# ***Interactive comment on “The Niwot Ridge Subalpine Forest US-NR1 AmeriFlux site – Part I: Data acquisition and site record-keeping” by S. P. Burns et al.***

## **Reply to Referee #2**

Date: August 6, 2016

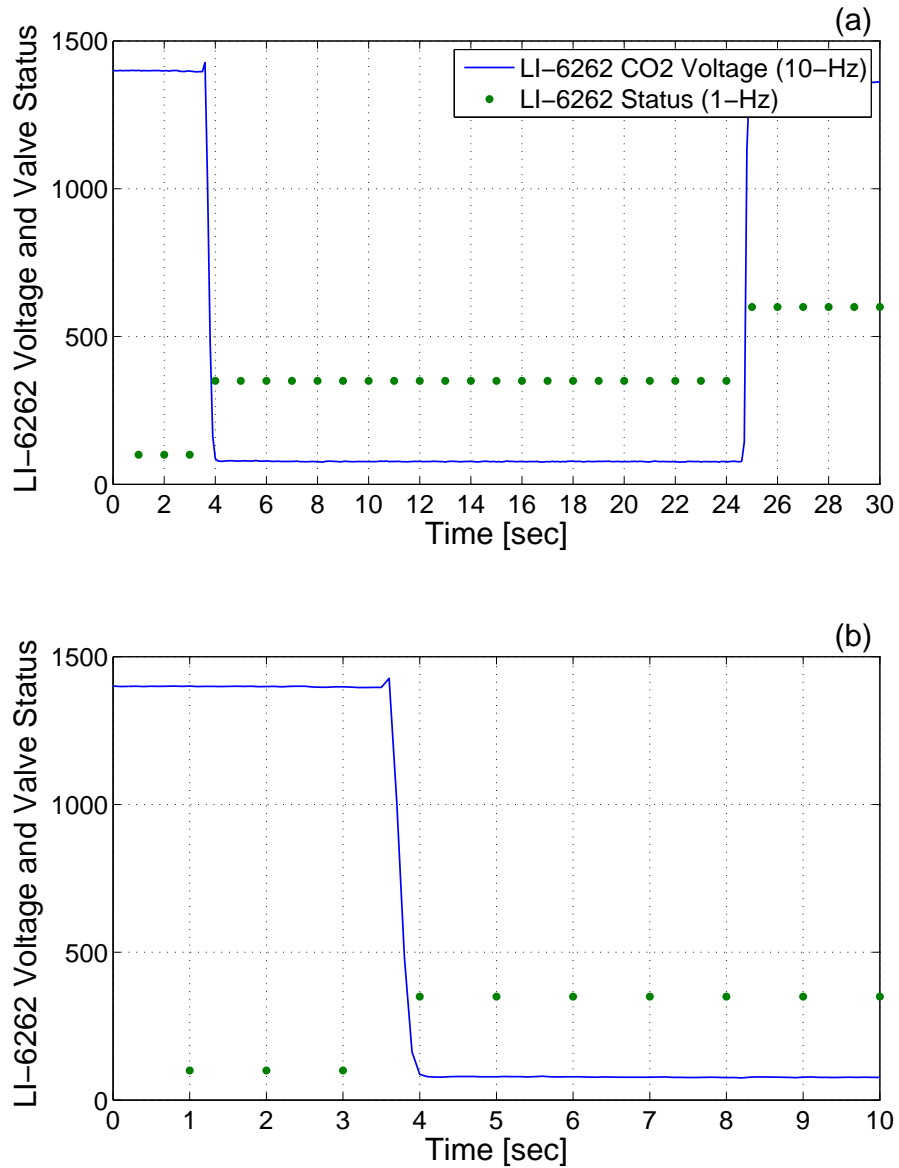
*Comment 2: (2) Section 4.1, page 10 – the time when the LI-6262 IRGA samples the nitrogen is recorded based on the data system clock. This is the time when nitrogen enters the sampling chamber of IRGA. MET logger (CR23X) records the time when valves open. There should be a delay (very tiny though) between the valve opening and calibration gas entering into the IRGA. Should this delay be included in considering the CR23X clock drift?*

Reply to Comment 2: It is true that there is a lag time between the valve changing and LI-6262 going to zero. Because of the rather high flow rate ( $\approx 8-9$  lpm) used, this lag time is on the order of 0.5 sec (an example is shown in Fig. R1 at the end of this reply). This small lag would cause a small shift in the estimated lags shown in Fig. 7 of the manuscript; however, all the points would be shifted equally so the overall drift of the logger with time, which is the main point of Fig. 7, would be unchanged. For this reason, we have left Fig. 7 as-is.
